Technical Service Bulletin

37 Transmission malfunction, DTC P17F600, U008000, and/or U010100 stored in TCM or ECM

37 19 85 2053878/2 March 12, 2019. Supersedes Technical Service Bulletin Group 37 number 19-84 dated February 26, 2019 for reasons listed below.

Model(s)	Year	VIN Range	Vehicle-Specific Equipment
A6, A7	2019	000001 - 050600	3.0TFSI

Figure 1. Common areas for harness damage.

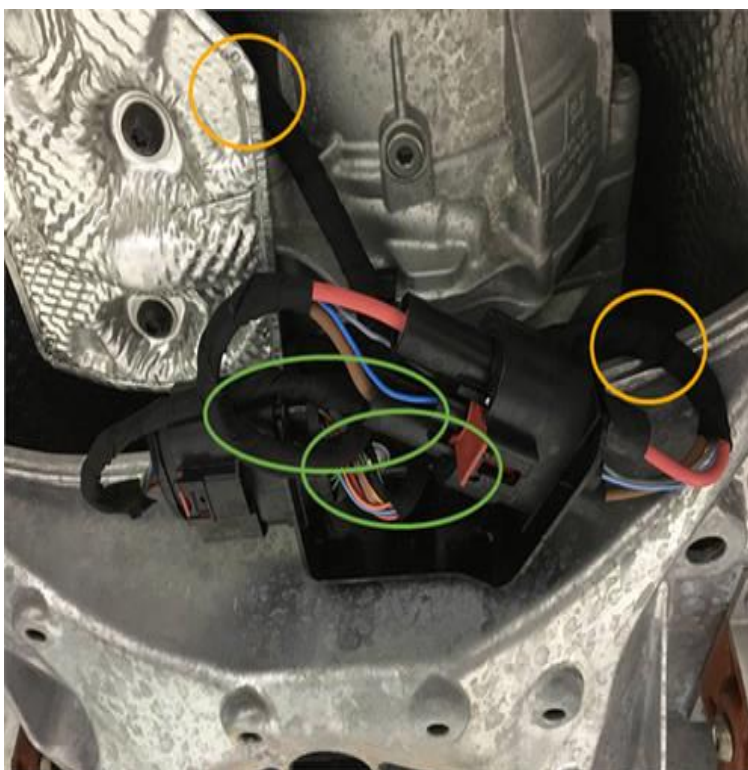
The transmission harness can come in contact with the crossmember and could be damaged.

1. Inspect for damage to the transmission harness (Figure 1 - 4).
 - Thoroughly inspect the transmission wiring harness for damage.
 - Harness damage can be very subtle. Even a light chafing of the harness wrap can cause the DTCs.
 - If there is no harness damage found, please contact TAC.

2. Replace the transmission harness with a new part and reroute the transmission harness. The transmission harness should not be repaired.

Figure 5. Routing and wrapping of the aft part of the transmission harness.

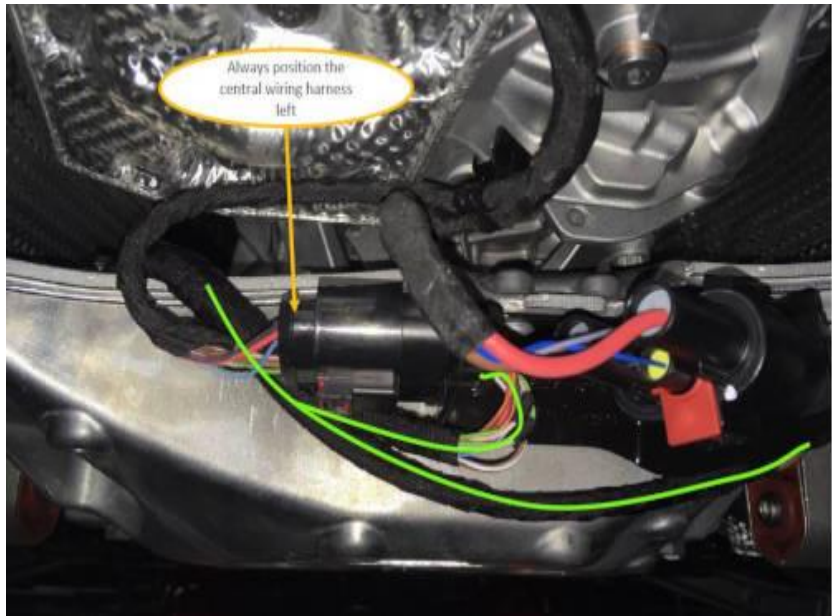
- Remove the old transmission harness in the vehicle.
- Wrap the exposed wires on the new transmission harness as shown in Figure 5.
- Mount and route the new transmission harness as shown in Figure 6.

3. The crossmember is shown dismounted in Figure 6 to show the new mounting points more clearly.
For mounting and installation of the new transmission harness, the cross-member does not have to be disassembled.
